**PERISHER BLUE SKI RESORT  
AUTOMATION OF LOWER ROLLER COASTER RUN  
SNOWMAKING SYSTEM**

**DEVELOPMENT APPLICATION  
No. DA 036-08-2011  
SUPPLEMENTARY REPORT**

Prepared on behalf of  
Perisher Blue Pty Ltd  
for the  
Department of Planning

February 2012

Figure 2.1b Proposed variation

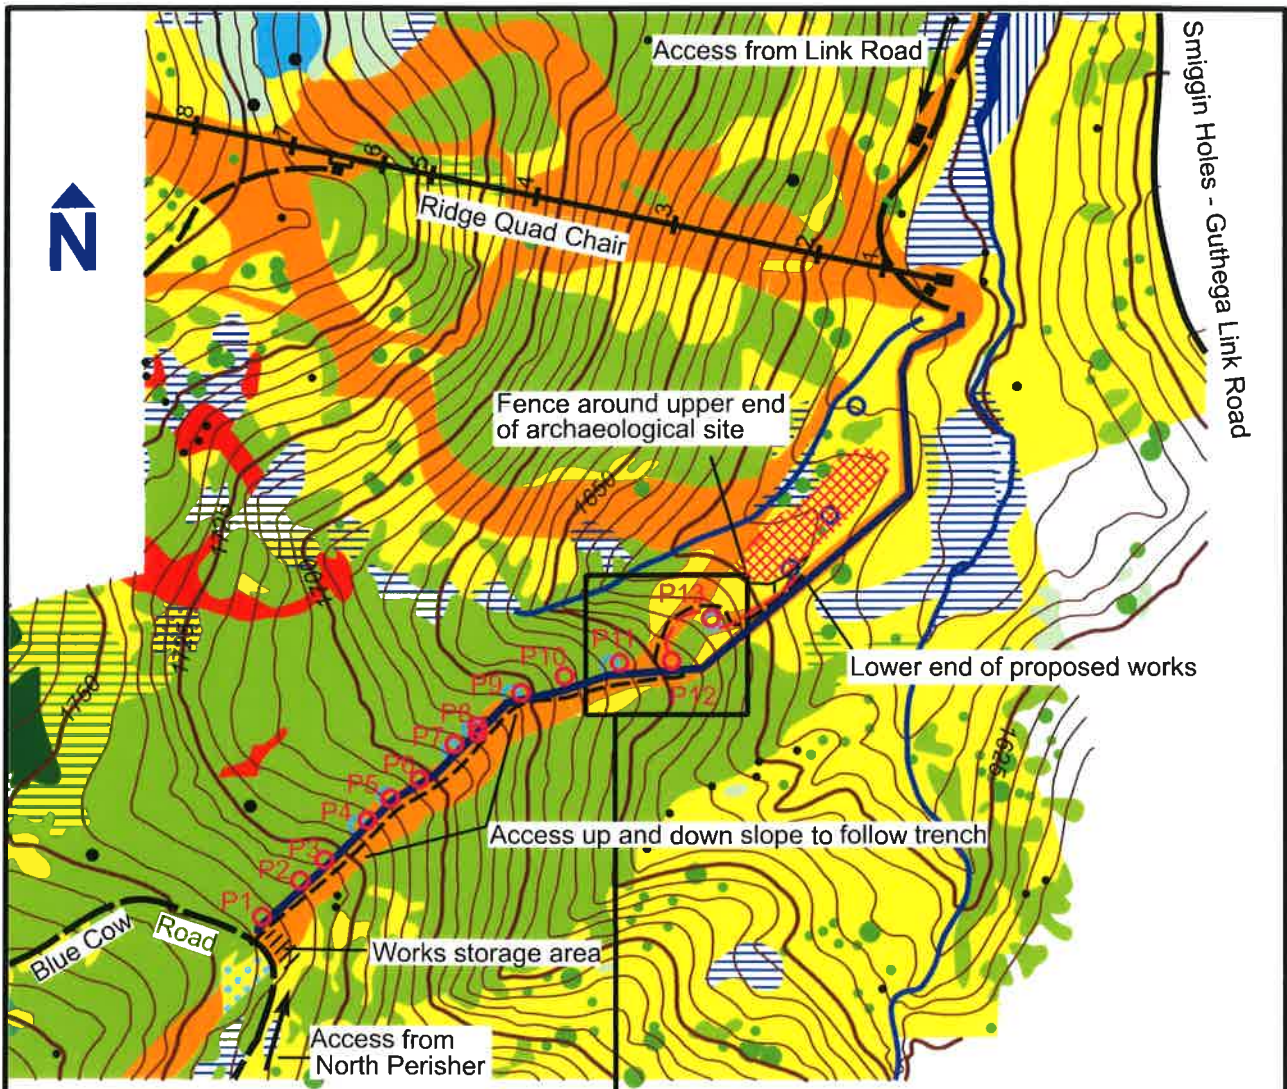
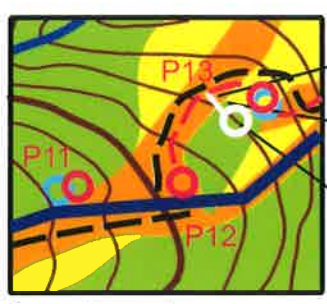
The variations to the proposed works, shown in Figure 2.1b, are:

- an alteration of the proposed location of P13; and
- the removal of a small clump of mostly regenerating snow gums.

The proposed variation to the approved development application (DA 036-08-2011) would locate P13 approximately 18 metres to the south-west and upslope from the existing hydrant. Snowmaking from a more elevated position would increase the time taken for the made snow to fall to the ground, thereby providing more time for the snow to freeze and dry out. The result is an increase in snow cover and a drier product, which provides a better surface for skiing and snowboarders. Overall, the increase in elevation would improve the efficiency of snowmaking operations in the localised area.

- A new lateral trench to provide services to P13 from the approved lateral line. The new trench would be about 14.5 metres in length and would require the removal of additional woodland understorey/ dry heath vegetation.

The proposed new locations for P13 and the lateral trench are shown in Plate 1 and Plate 2, and are indicated in Figure 2.1b. The location of the proposed trench is indicated with a dashed black line in Plate 1, while the centre of the proposed pit is marked by the post visible in both photographs.

*Plate 3.* A view of the area of the proposed works, taken from below the site. The proposed trench route is indicated by a dashed black line. The approved trench has been constructed.

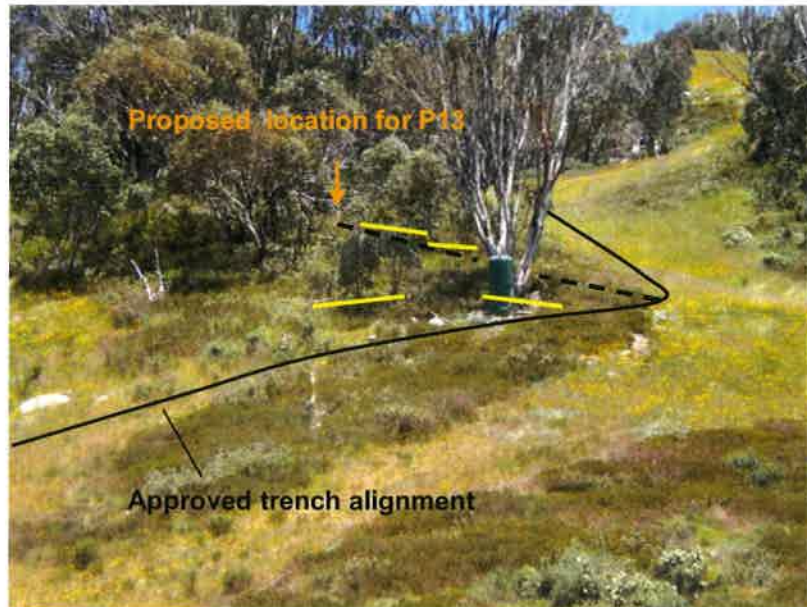
The trees and branches to be removed are shown in Plates 1 and 3, and are indicated with a yellow line. The shrubs and understorey grasses and forbs, other than that proposed for removal to construct the proposed lateral trench and pit, and that approved for removal in DA 036-08-2011, would be retained.
